REVISIONS					
P	LTR	DESCRIPTION	DATE	DWN	APVD
B		Revised as per ECR-23-174795 PCN-23-174854	01JUN2023	VK	GL

THIS DRAWING IS A CONTROLLED DOCUMENT.		DWN KYLIN YAO 05JUN2018	 TE Connectivity Ltd.					
		CHK KYLIN YAO 05JUN2018						
DIMENSIONS: mm	TOLERANCES UNLESS OTHERWISE SPECIFIED: 0 PLC ± - 1 PLC ± - 2 PLC ± - 3 PLC ± - 4 PLC ± - ANGLES ± -	APVD DAVID ZHANG 05JUN2018	NAME					
		PRODUCT SPEC	MINI SAS HD TO MINI SAS HD					
		APPLICATION SPEC	4X					
		WEIGHT	-					
MATERIAL	FINISH	0	SIZE	CAGE CODE	DRAWING NO	RESTRICTED TO		
		-	A1	00779	C2337815	-		
		CUSTOMER DRAWING	SCALE	1:1	SHEET	1 OF 2	REV	B

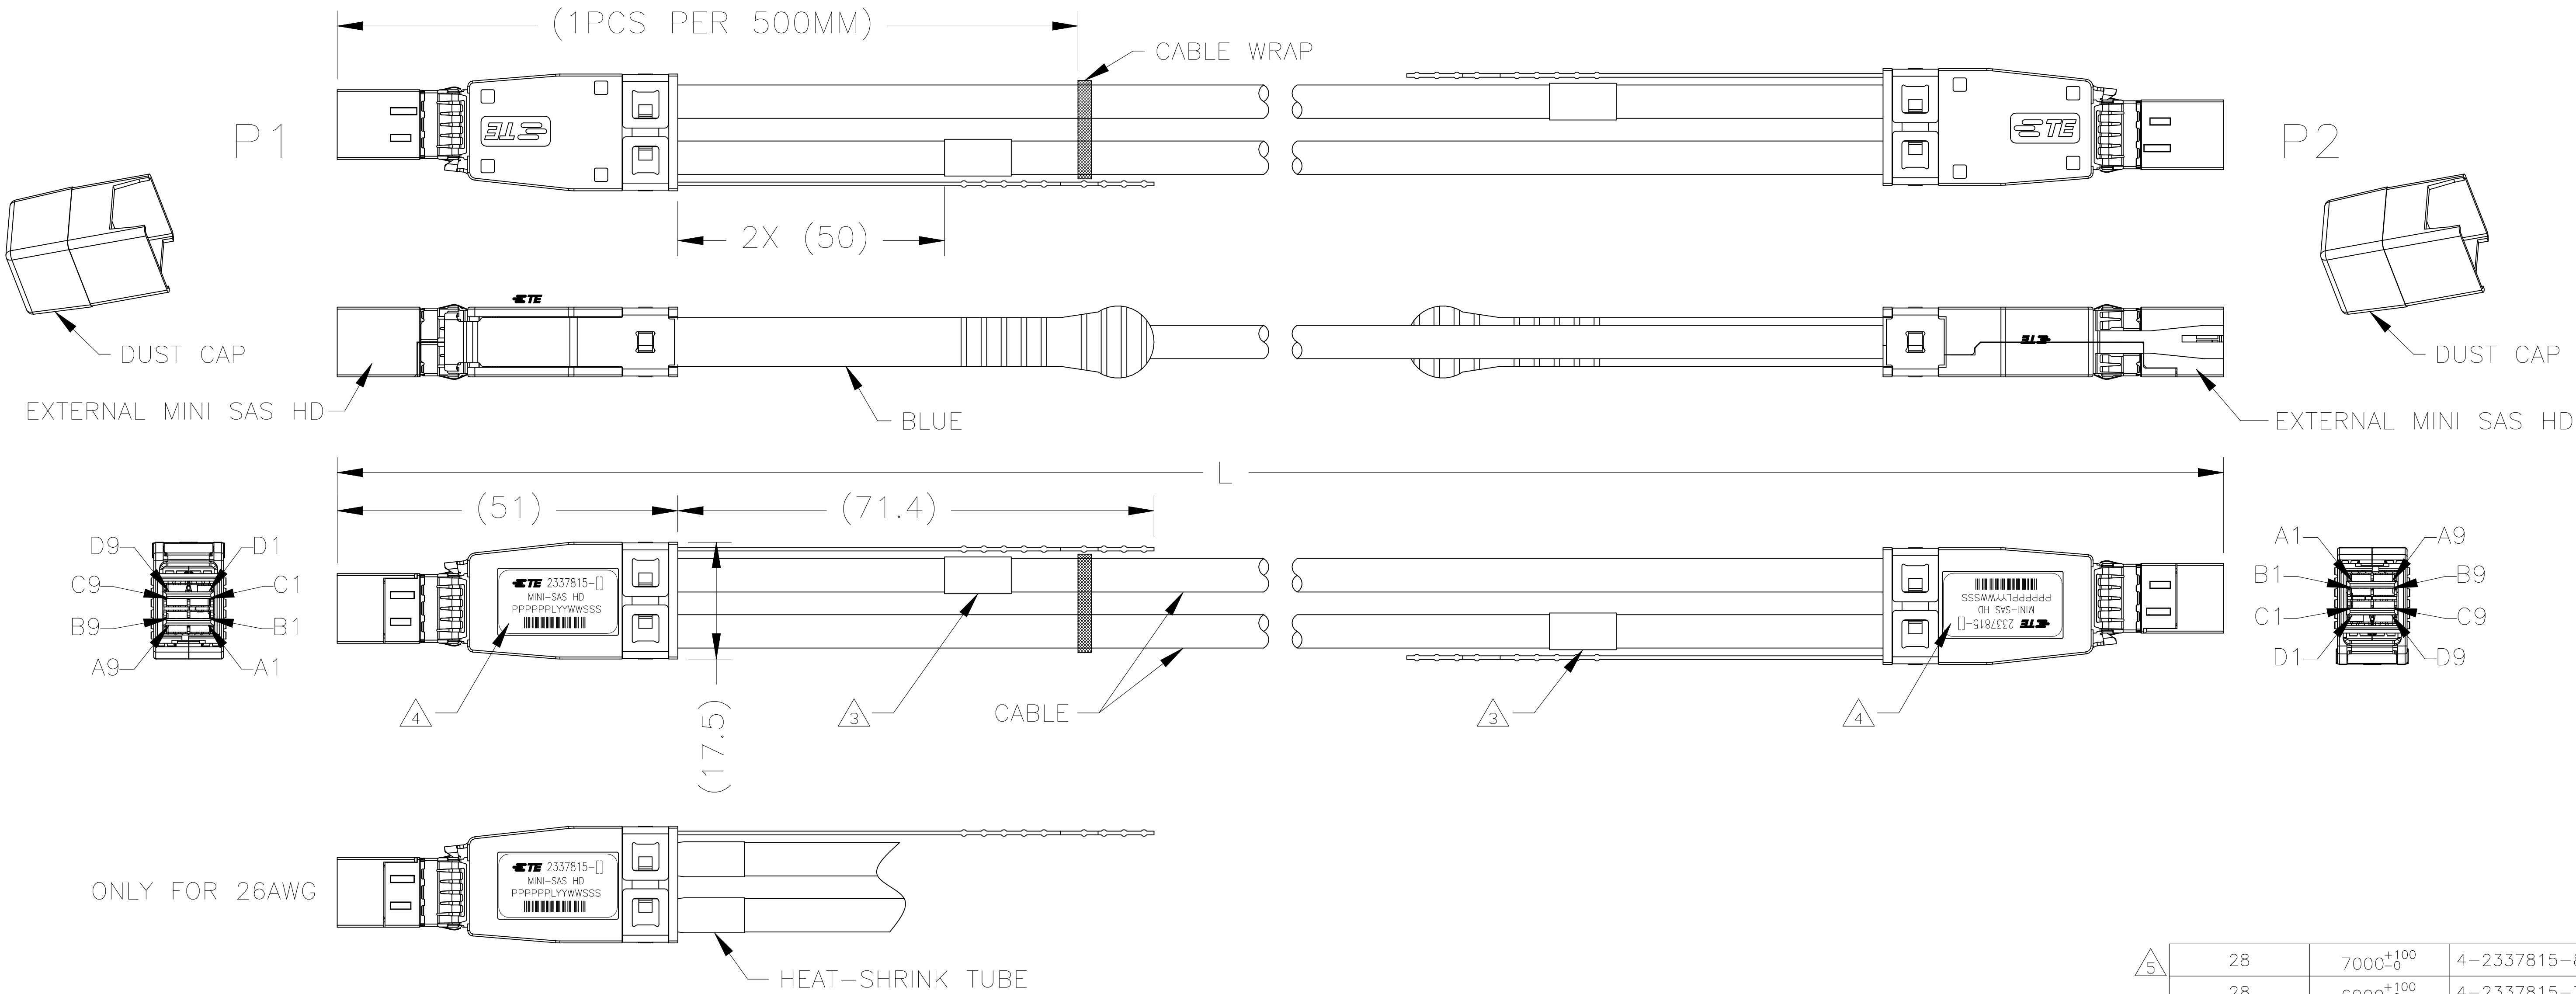
- △5 4-2337815-8 CAN NOT MEET SI SPECIFICATION OF SAS3.0.
- △6 THE RAW CABLE IS BEEN CHANGED FROM 4 PAIR 28 AWG 10G CABLE TO 4 PAIR 30 AWG 25G CABLE DUE TO UNAVAILABILITY OF 28 AWG 10G CABLE (END OF LIFE)

△5	28	7000 ⁺¹⁰⁰ ₋₀	4-2337815-8
	28	6000 ⁺¹⁰⁰ ₋₀	4-2337815-7
	28	5000 ⁺¹⁰⁰ ₋₀	4-2337815-6
	28	4000 ⁺⁸⁰ ₋₀	4-2337815-5
	28	3000 ⁺⁸⁰ ₋₀	4-2337815-4
	28	2000 ⁺⁸⁰ ₋₀	4-2337815-3
	28	1000 ⁺⁵⁰ ₋₀	4-2337815-2
	28	500 ⁺⁵⁰ ₋₀	4-2337815-1
△6	30	3500 ⁺⁸⁰ ₋₀	2-2337815-7
△6	30	5000 ⁺¹⁰⁰ ₋₀	2-2337815-6
△6	30	4000 ⁺⁸⁰ ₋₀	2-2337815-5
△6	30	3000 ⁺⁸⁰ ₋₀	2-2337815-4
△6	30	2000 ⁺⁸⁰ ₋₀	2-2337815-3
△6	30	1000 ⁺⁵⁰ ₋₀	2-2337815-2
△6	30	500 ⁺⁵⁰ ₋₀	2-2337815-1
	30	3000 ⁺⁸⁰ ₋₀	2337815-4
	30	2000 ⁺⁸⁰ ₋₀	2337815-3
	30	1000 ⁺⁵⁰ ₋₀	2337815-2
	30	500 ⁺⁵⁰ ₋₀	2337815-1
	AWG	L	PART NO.
